**PLANNED UNIT DEVELOPMENT  
STAFF REPORT****Date: April 5, 2007****DEVELOPMENT NAME** Clearbrook, LLC**LOCATION** 4071 Halls Mill Road, 1521 and 1525 Azalea Road  
(East side of Azalea Road, 300' ± South of Halls Mill Road.)**CITY COUNCIL  
DISTRICT** Council District 4**PRESENT ZONING** I-1, Light Industrial**AREA OF PROPERTY** 11.37± Acres**CONTEMPLATED USE** Planned Unit Development Approval to allow an office building, light manufacturing building, equipment storage, vehicle storage, guard house, and model unit displays on a single building site, to be developed in phases.**TIME SCHEDULE  
FOR DEVELOPMENT** In Phases, no time schedule provided**ENGINEERING  
COMMENTS** Must comply with all storm water and flood control ordinances. Any work performed in the right of way will require a right of way permit.**TRAFFIC ENGINEERING  
COMMENTS** Driveway number, size, location, and design to be approved by Traffic Engineering and conform to AASHTO standards.**URBAN FORESTRY

**RECOMMENDATION:** Based on the preceding, this application is recommended for holdover until the April 5 meeting to allow the applicant to address the following:

# SITE PLAN

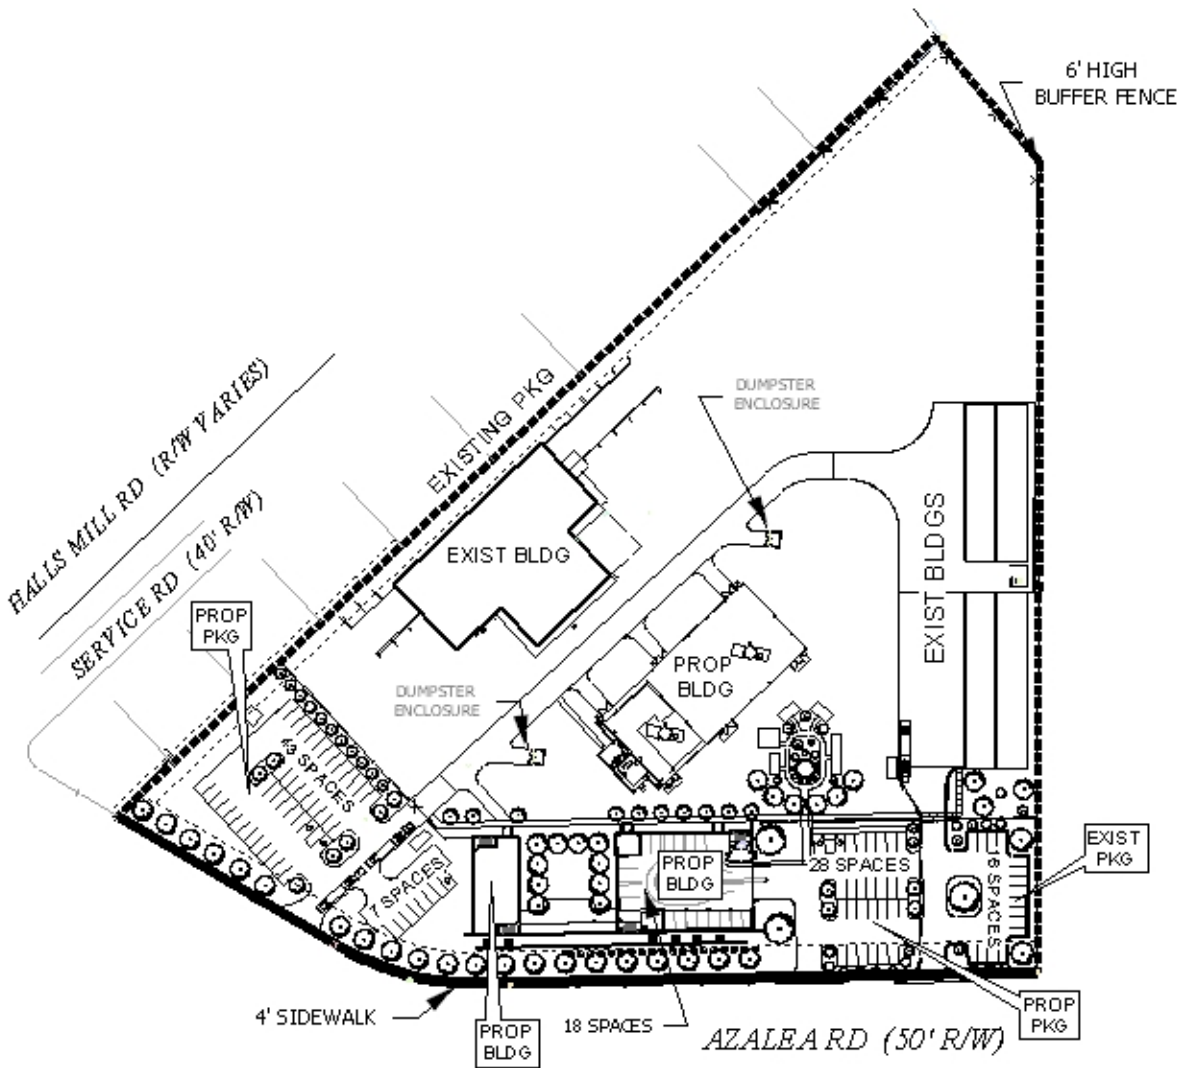
As PUD approval is site plan specific, it is imperative that adequate information be provided on the site plan and in the narrative description of the development. In this particular instance, neither the site plan nor the narrative provides adequate information regarding the proposed development for consideration for anything more than conceptual review of the proposed master plan. There is no information regarding building sizes was provided (square footage is needed for parking calculations); no information is provided regarding numbers of employees for the warehousing/light manufacturing buildings (also needed for parking calculations); no dimensions are shown for parking stalls, aisles, drives or internal circulation road for tractor trailers; a dumpster location is not shown; a buffer fence is shown, but is not adjacent to all residentially zoned property; and existing curb cuts that are not to be used are not noted as being removed.

1. Provide information regarding building sizes (square footage is needed for parking calculations);
2. Provide numbers of employees for the warehousing/light manufacturing buildings (also needed for parking calculations);
3. Provide dimensions for buildings, parking stalls, aisles, drives and internal circulation road for tractor trailers;
4. Illustrate dumpster location, access and screening on site plan;
5. Illustrate buffer fence adjacent to all residentially zoned property; and
6. Illustrate existing curb cuts that are not to be used as being removed

The applicant has submitted a revised plan which addresses the issues listed as reason for holdover. Therefore, this application is recommended for approval subject to the following conditions:

1. landscaping and tree plantings be installed with each phase of development, as identified on the phasing plan submitted;
2. required buffering along rear of site be installed with Phase I of development; and
3. full compliance with all municipal codes and ordinances.
